# Storage Bridge Bay (SBB) Specification 1.0 Errata

Revision B

January 14, 2007

This document contains errata to SBB Specification Version 1.0. It is the intention of the SBB Working Group to incorporate the errata in the next revision of the SBB specification.

**Figure 7: Air Inlet and SBBMI Module Locations**

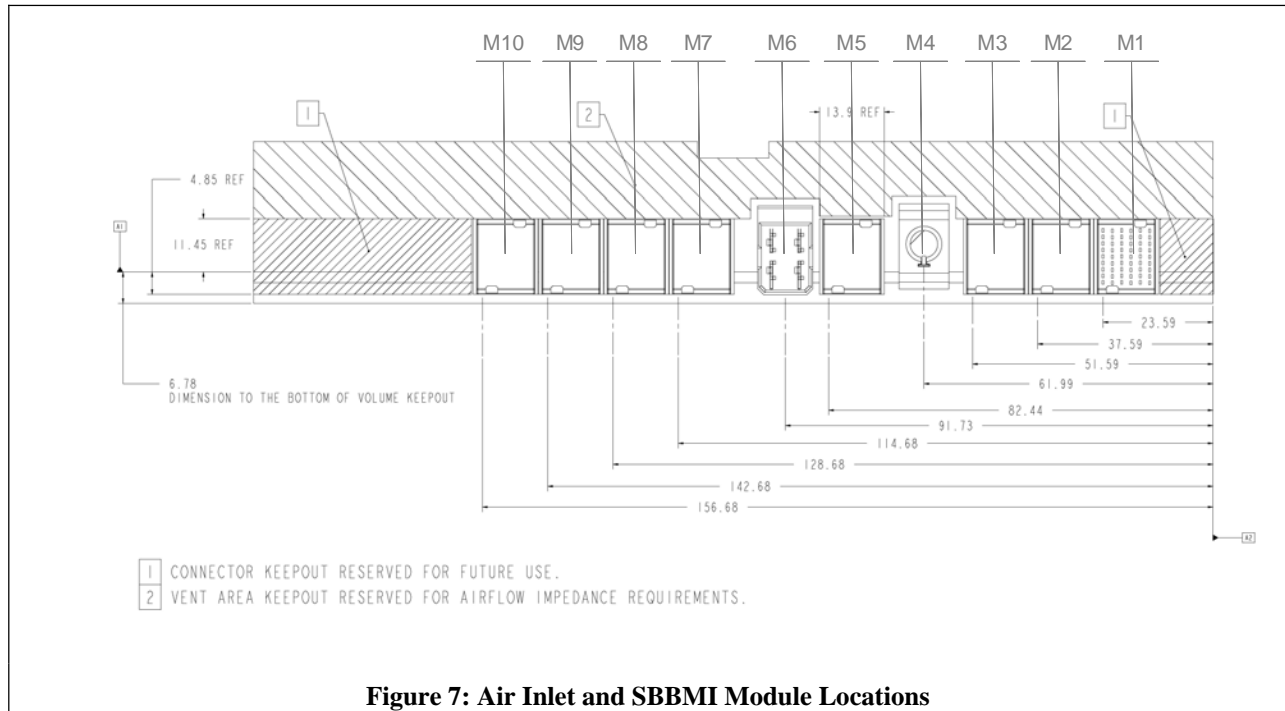
The dimensions listed in Figure 7 for some of the signal module locations are incorrect. Figure 7 will be replaced with the following figure that contains the correct dimensions:

Figure 15: SBBMI Canister Power Header Dimensions<sup>5</sup>

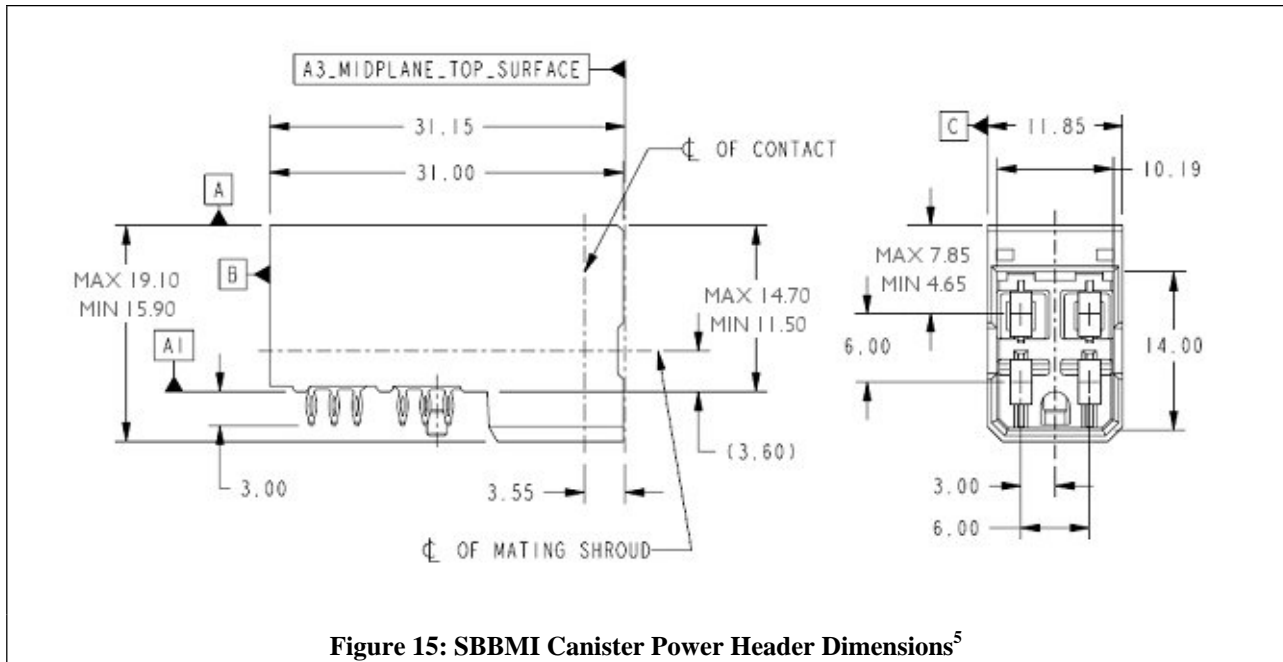
The SBBMI canister power header described in this section could have a smaller height dimension from reference plane A1 and be fully compatible with the SBBMI midplane power receptacle. Figure 15 will be replaced with the following figure.

Figure 16: Recommended PCB Layout<sup>5,6</sup>

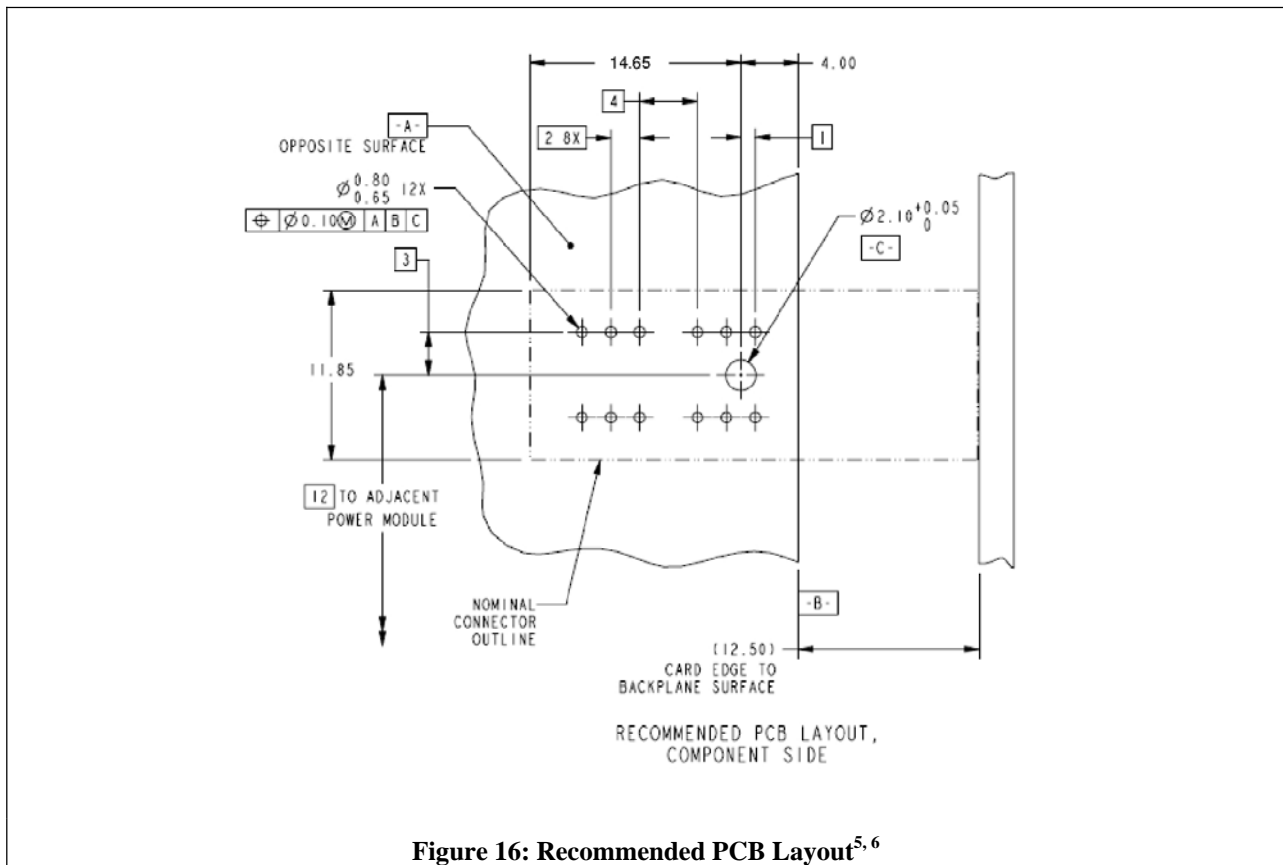
One of the dimensions listed in Figure 16 is incorrect. Figure 16 will be replaced with the following figure.

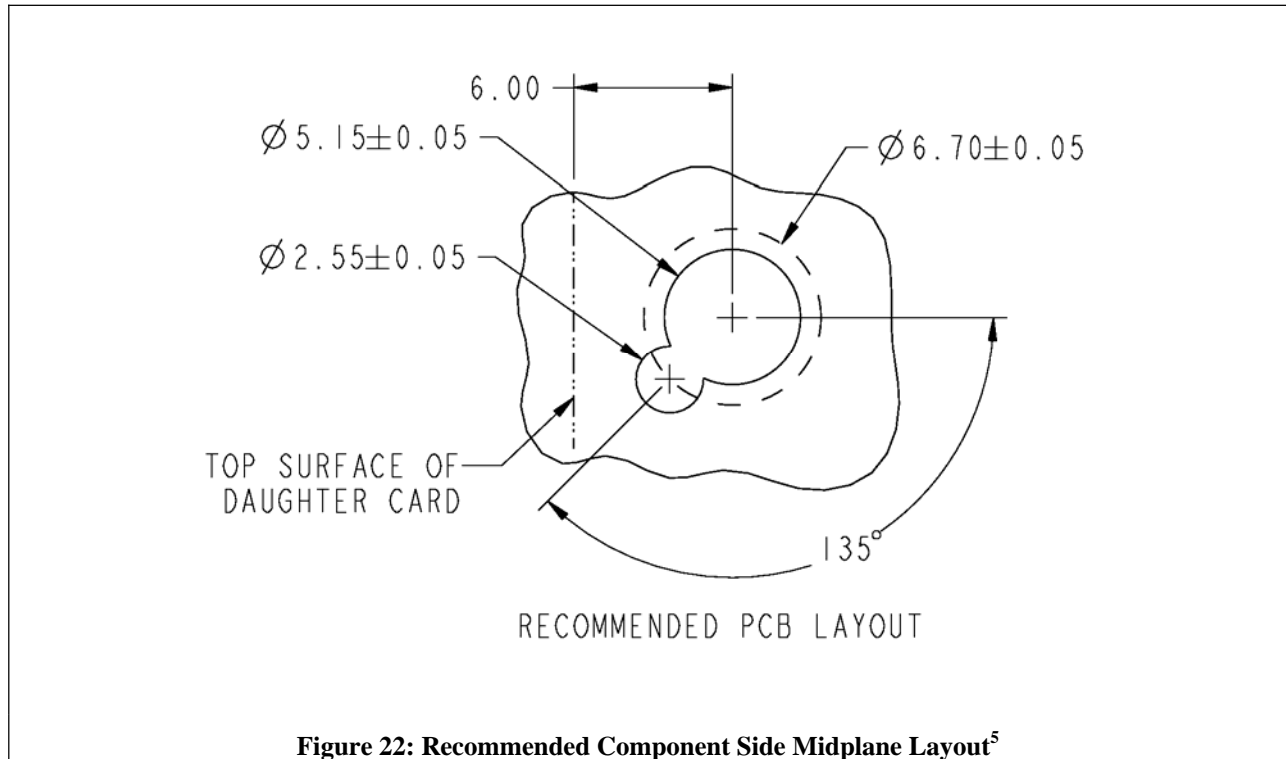
The dimension shown in Figure 22 for the distance from the “Top Surface of Daughter Card” to the center of the guide pin is incorrect. Figure 22 will be replaced with the following figure that contains the correct dimension.

**Figure A - 15: Recommended Component Side Midplane Layout<sup>1</sup>**

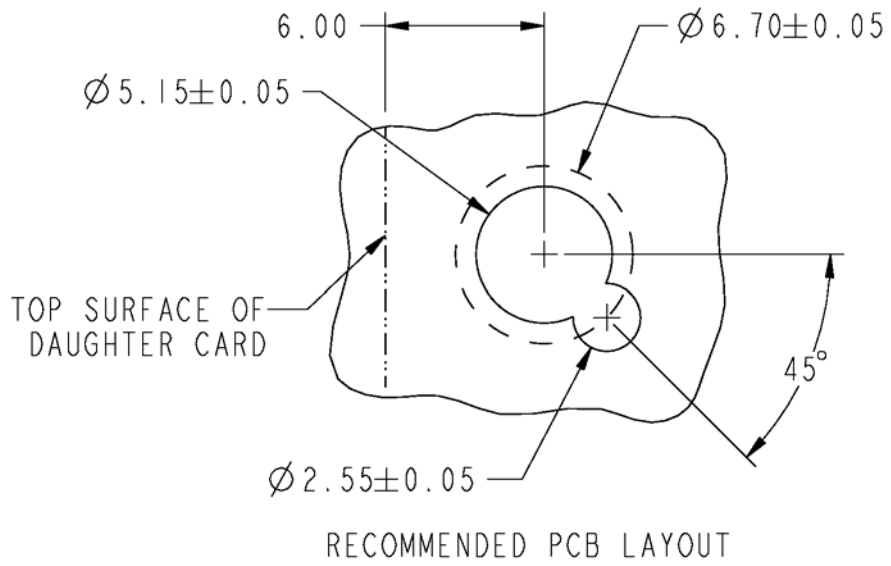
The dimension shown in Figure A – 17 for the distance from the “Top Surface of Daughter Card” to the center of the guide pin is incorrect. Figure A – 17 will be replaced with the following figure that contains the correct dimension.
